The International Small Group and Tree Planting Program, Kenya, VCS-006

Project Title	The International Small Group and Tree Planting Program, Kenya, VCS-006
Version	Version 2
Report ID	GR14W0007D

Report Title	VCS Verification Report: The International Small Group and Tree Planting Program, Kenya, VCS-006, Verification 02
Client	Clean Air Action Corporation P.O. Box 4607 Tulsa OK, USA 74159 Telephone 918-747-8749 CharlieWilliams@CleanAirAction.com Tist.org
Pages	35 pages + appendix 56 pages
Date of Issue	24-September-2014
Prepared By	JACO CDM
Contact	Office at: 2-2-19 AKASAKA, MINATO-KU, TOKYO, 107-0052 JAPAN Phone: +81-3-5572-1753, Fax: +81-3-5572-1730
Approved By	Akihide MADENOKOJI (Lead Auditor, General Manager of Assessment Division of JACO CDM)
Work Carried Out By	Teruo FUKUDA (Lead Auditor, Verification team leader), Takahiro YUGUCHI (Lead Auditor, Verification team member)

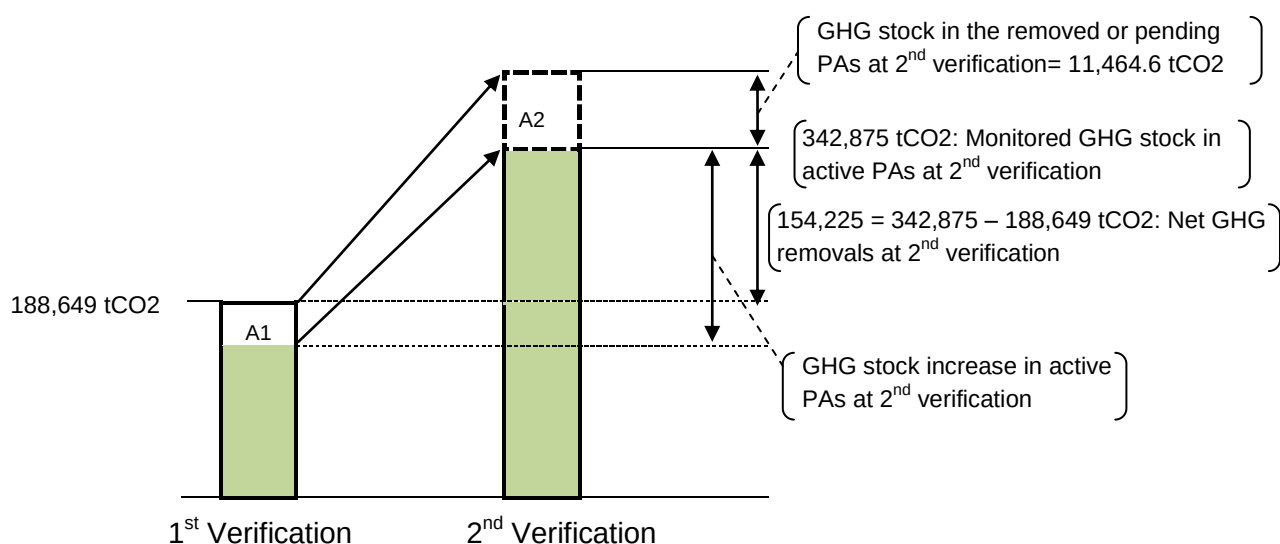
It was confirmed from the interviews with CAAC & TIST and review of spreadsheet /2/ that 173 Project Areas (1.66% of the carbon volumes) have been removed from the PD since validation and the first verification. In addition, 1,005 PAs (1.68% of the carbon volumes) have been put in a "Pending" category. The status of each individual PA is indicated in column AO of the "PA Summary" worksheet, verification data spreadsheet /2-6/. The carbon of all removed or pending PAs have been conservatively set to zero.

The present status of removed PA and pending PAs are discussed and described in CL 3 below.

The description was added to the revised monitoring report version 07 section 2.1. /2-6/ **(CL 3)**

Total carbon of the 173 removed PAs and 1005 pending PAs is calculated as $5,706.8 + 5,757.8 = 11,464.6 \text{ tCO}_2$ and 3.34% of the carbon stock $342,874 \text{ tCO}_2$. /2-6/ The value is less than 5% (materiality threshold value applicable to the project).

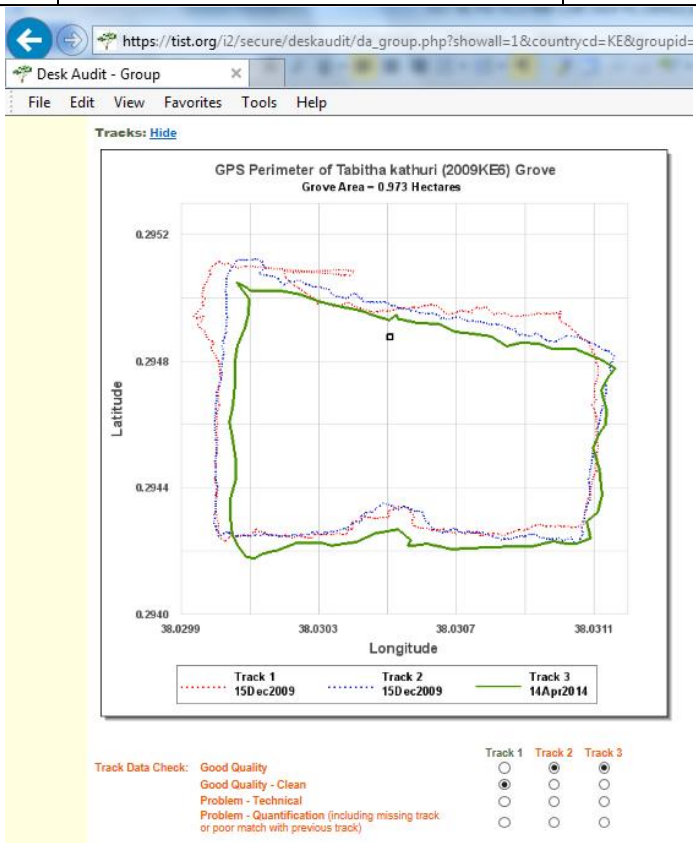
<u>Clarification Request 3</u> (1) Please inform about the present status of inactive PAs and how	B1.1	(1) The status of each individual PA, i.e. whether it is active or inactive, is addressed in column AO of the "PA Summary" worksheet, verification data spreadsheet. If the column	OK (1) It is confirmed that the status of each PA is addressed in column AO

Corrective action, clarification and forward action requests	Ref. to checklist Table 1	Summary of project owner's response	Conclusion
to address to these PAs. (2) What is the reasons of the removals these PAs. (3) Whether the changes would have been known prior to registration and how the changes would impact the overall operation/ ability of the project activity to deliver emission reductions as stated in the PD, (4) The impact to the conclusions of validation report of the registered PD (Additionality, Scale, Applicability of methodology, compliance of the monitoring plan, level of accuracy of the monitoring), (5) The impact to the non-permanence risk is to be explained. (6) It is to be confirmed about the special events which might impact the applicability of the methodology during the monitoring period.		indicates something other than active, they are inactive. All carbon of each inactive PAs have been set to zero. This means that remaining PAs must first make up the carbon loss before any new credits can be issued. (2) Much of the following has been added to Section 2.1 of the monitoring report. There are several reasons for the removal of the PA and each is listed in column AO of the "PA Summary" worksheet, verification data spreadsheet. First, however, you will note that each category description is preceded by a "treatment" code. The codes are as follows: 1. Active: These are PAs that are active in TIST and have valid tree counts and calculated carbon volumes. Only Active PAs contribute to the carbon volume of this verification. 2. Pending: These are PAs that need to be reviewed to determine if they will continue as TIST PAs or need a current quantification. They will still be listed on the PA Summary sheet to acknowledge they are currently part of the PD but for this verification their trees and carbon are zero. Once their circumstances have been reviewed, they will either be removed or listed as active. If they are listed as active, we will re-establish the tree count and carbon in subsequent verifications. 3. Removed: These PA are being permanently removed from the program. They will still be listed on the PA Summary sheet to acknowledge they were part of the PD but their trees and carbon are zero. They will not participate in the future. The following describes the different categories and the way they are treated: a. Pending: Baseline Error: These are cases where the baseline and boundaries of a grove were taken at one location but the farmer decided to plant somewhere else. Due to the rules of VCS, the groves with the trees are not part of this PD. The baselined area can still be a	of the PA Summary worksheet. It is confirmed by the spreadsheet that all carbon of each PA which is other than active has been set to zero. According to the spreadsheet of the monitoring report for 2nd verification version 1 dated 21/01/2014, carbon of 604 PAs among original 18,099 PAs have been removed and set to zero. Further, during the 2nd on-site visit and later, TIST and their quantifiers reviewed the status of each PA precisely and finally carbon of 574 PAs have been additionally set to zero, that is, carbon of total 1178 PAs (604 + 574 = 1178) have been set to zero. It is conservative and appropriate. (2) The reasons of Pending and Removed are explained in detail in the revised monitoring report ver. 7. /1-7/ The status and category of each PA are clearly indicated in the spreadsheet. /2-6/ It is confirmed from the assessment and interviews from PP and quantifiers that the explanation is covering all the situations happening and appropriate. (3) It was confirmed by the spreadsheet that total carbon of the removed PAs and pending PAs is calculated as 5,706.8 + 5,757.8 = 11,464.6 tCO₂ and 3.34% of the carbon stock at the 2nd verification
